To: T10 Technical Committee  
From: Rob Elliott, HP (elliott@hp.com)  
Date: 3 May 2006  
Subject: 05-322r3 SAS-2 Wide port simultaneous connection rules

**7.12.2 Opening a connection**

**Figure 2 — Example simultaneous connection recommendations for wide ports**

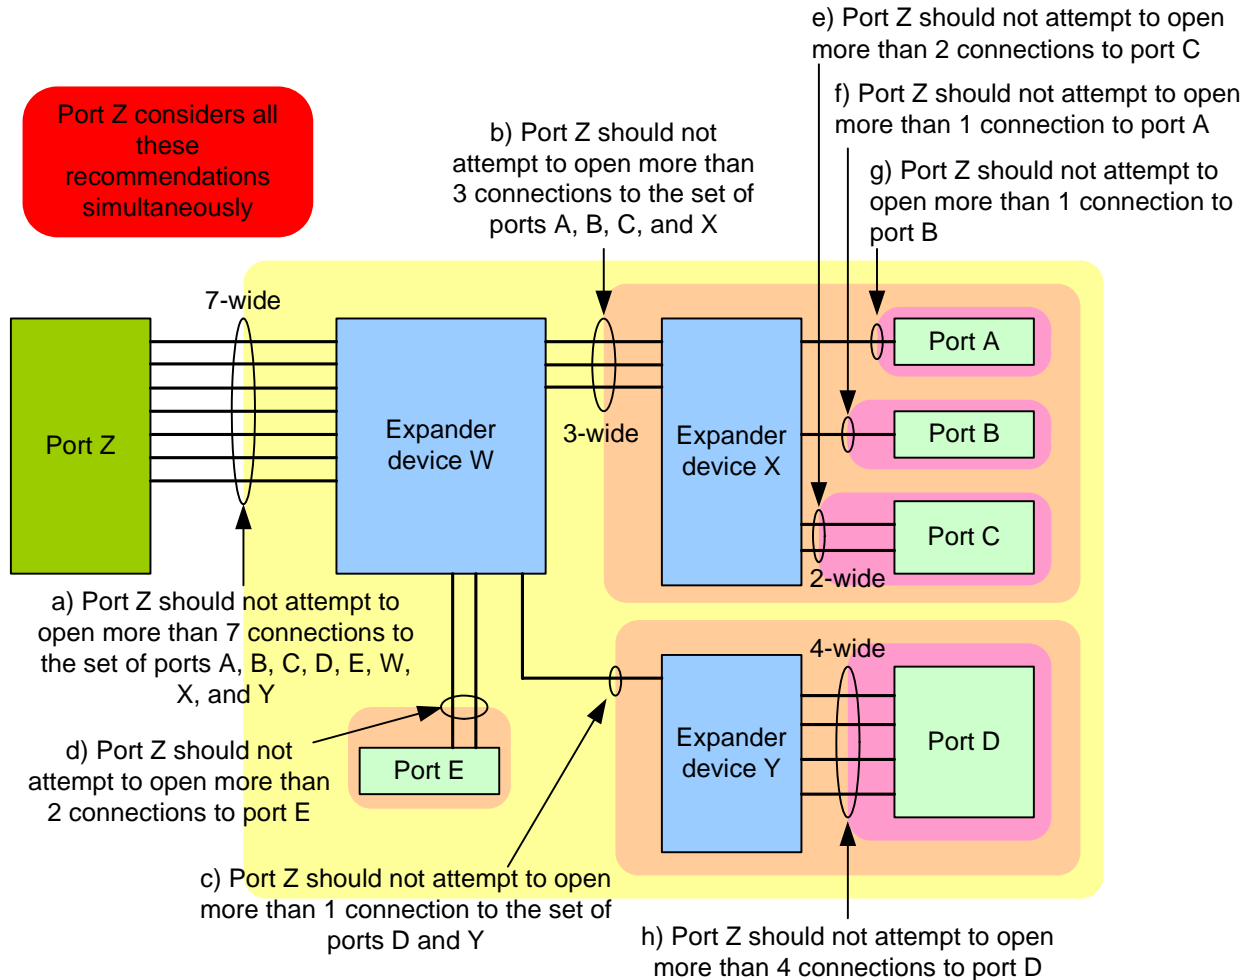
[A wide port should not attempt to establish more connections to a destination port than the destination port width or the width of the narrowest physical link on the pathway to the destination port. A wide port should not attempt to establish more connections to a set of destination ports than the width of the narrowest common physical link on the pathways to that set of destination ports. Additional requirements for STP connection requests are defined in 7.17.6. Additional requirements for SMP connection requests are defined in 7.18.x.](#)

Figure 2 shows an example of the simultaneous connection recommendations for wide ports.

Recommendations a), b), and g) together mean port Z should not attempt to open more than 2 connections to port C.

Recommendations a), b), e), f), and g) together mean that if port Z has 2 connections open to the set of ports A, B, and X, it should not attempt to open more than 1 connection to port C. If it has 6 connections open to the set of ports A, B, D, E, W, X, and Y, it should not attempt to open more than 1 connection to port C.

Recommendations a), c), and h) together mean port Z should not attempt to open more than 1 connection to port D. If it has a connection open to port Y, it should not attempt to open another connection to port D until the first connection is closed.

**Figure 3 — Example simultaneous connection rules for an expander device containing STP ports**

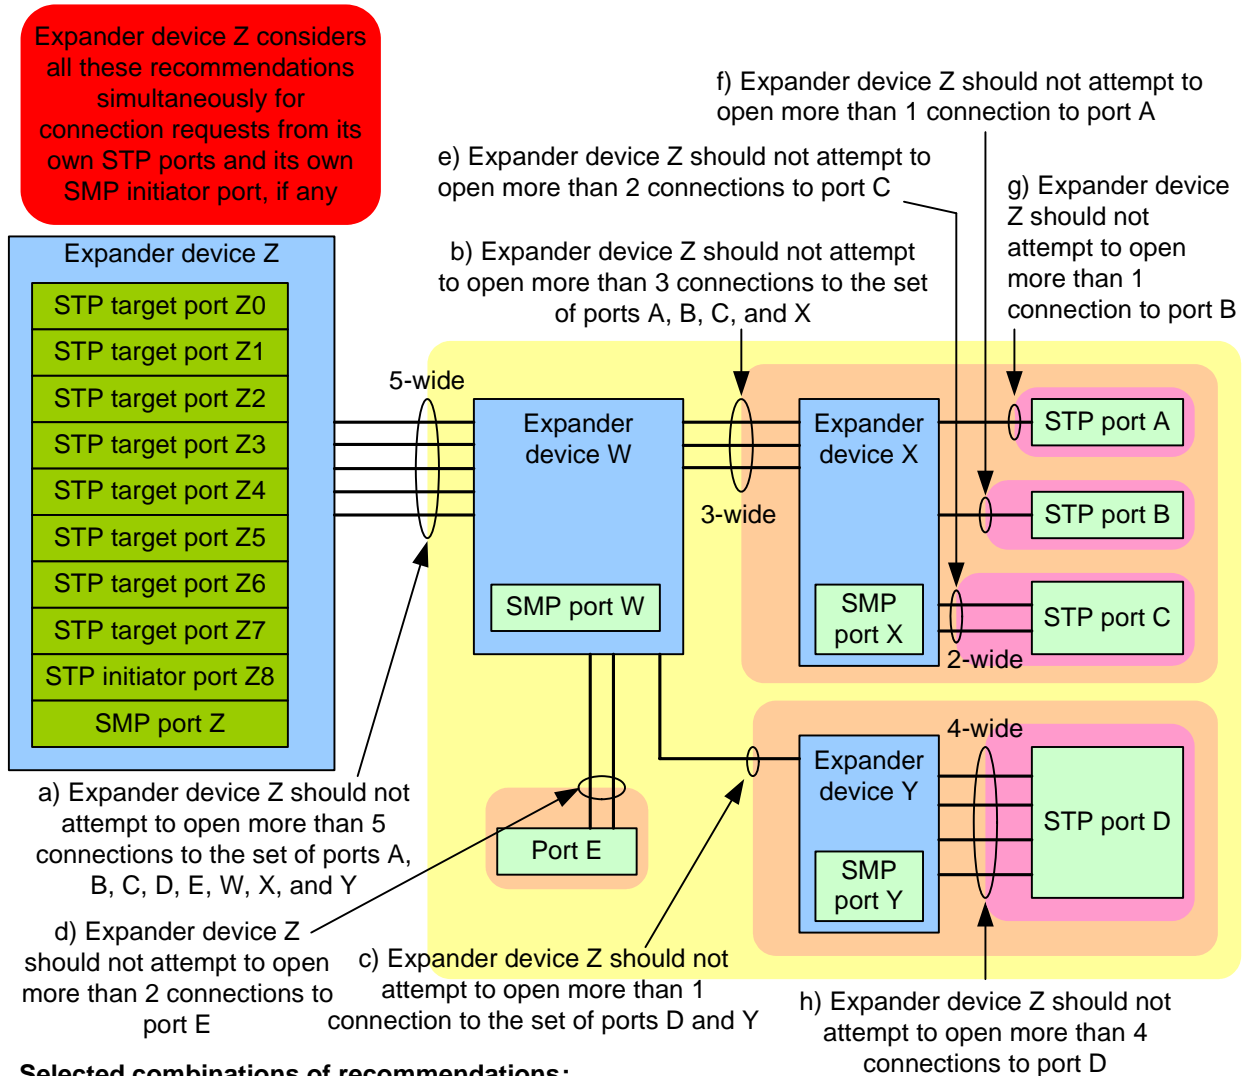
An expander device should not allow its set of STP ports (e.g., the STP target ports in STP/SATA bridges and any STP initiator ports in the expander device) to attempt to establish more connections to a specific destination port than the destination port width or the width of the narrowest physical link on the pathway to the destination port. This does not apply to connection requests being forwarded by the expander device.

An expander device should not allow its set of STP ports (e.g., the STP target ports in STP/SATA bridges and any STP initiator ports in the expander device) to attempt to establish more connections to a set of destination ports than the width of the narrowest common physical link on the pathways to that set of destination ports. This does not apply to connection requests being forwarded by the expander device.

Figure 3 shows an example of the simultaneous connection recommendations for an expander device containing STP ports.

Recommendations a), b), and g) together mean expander device Z should not attempt to open more than 2 connections to port C.

Recommendations a), b), e), f), and g) together mean that if expander device Z has 2 connections open to the set of ports A, B, and X, it should not attempt to open more than 1 connection to port C. If it has 4 connections open to the set of ports A, B, D, E, W, X, and Y, it should not attempt to open more than 1 connection to port C.

Recommendations a), c), and h) together mean expander device Z should not attempt to open more than 1 connection to port D. If it has a connection open to port Y, it should not attempt to open another connection to port D until the first connection is closed.
